Transmitted by the experts from France,
Germany, Norway and Sweden

Informal document No. GRSG-97-32-Rev.1
(97th GRSG, 20-23 Oct. 2009
agenda item 5)

Proposal for draft amendments to Regulation No. 118 (Burning behaviour of Materials)

Example 2

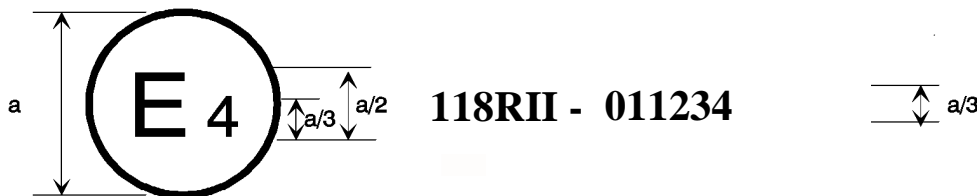
The above approval mark affixed to a component shows that the type concerned was approved in the Netherlands (E4) pursuant to Part II of Regulation No. 118 under approval number **011234**. The first two digits (**01**) of the approval number indicate that the approval was granted in accordance with the requirements of the **01 series of amendments to Regulation No. 118**.

Figure 4a
Apparatus for testing the capability to repel fuel or lubricant
(Dimensions in millimeters)"

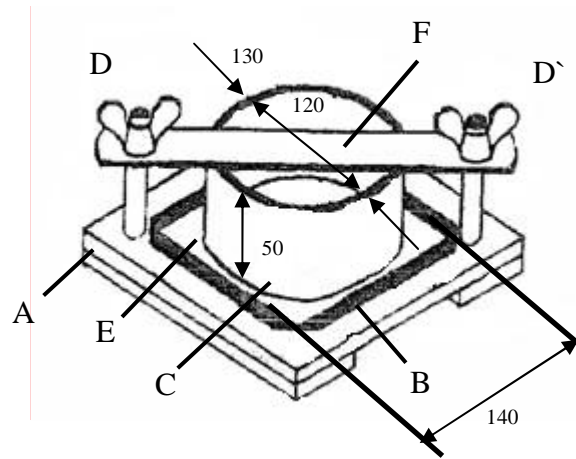
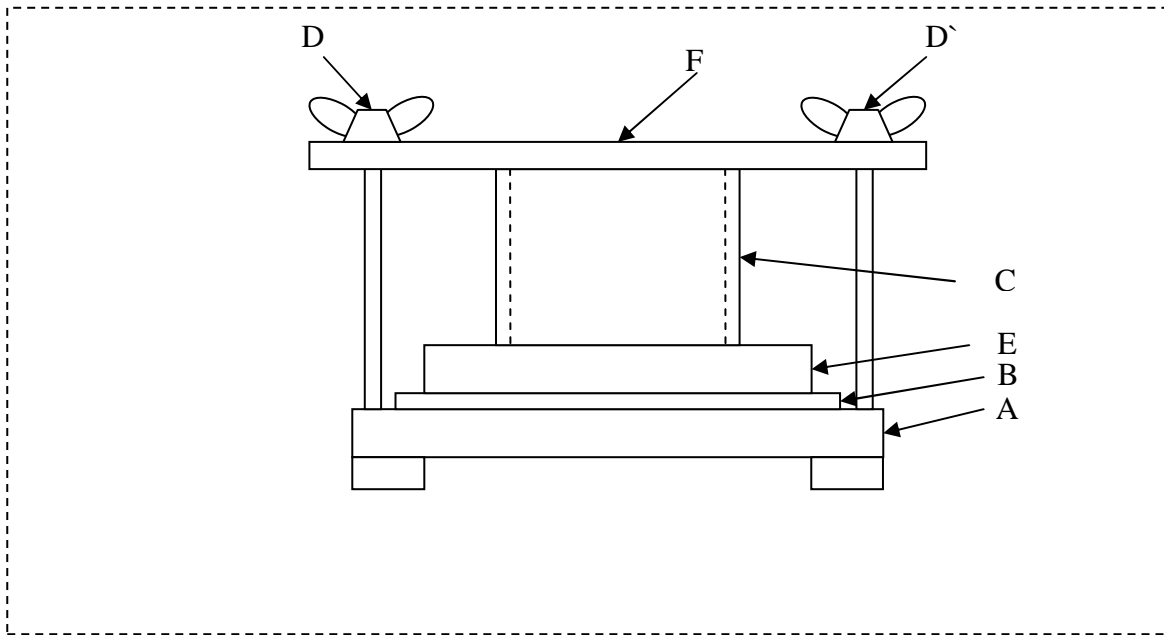
3. Apparatus (see figures 4a and 4b)

EA a seal base plate, with a hardness of at least 70 Shore D.

AB ~~a base plate with an~~ absorbant surface on the baseplate (e.g. paper);

BC a metal cylinder (inner diameter of 120 mm, outer diameter of 130 mm, height of 50 mm), filled with the test liquid;

~~C-C~~ **D-D'** two screws with wing nuts;

~~DE~~ the test sample;

F top plate
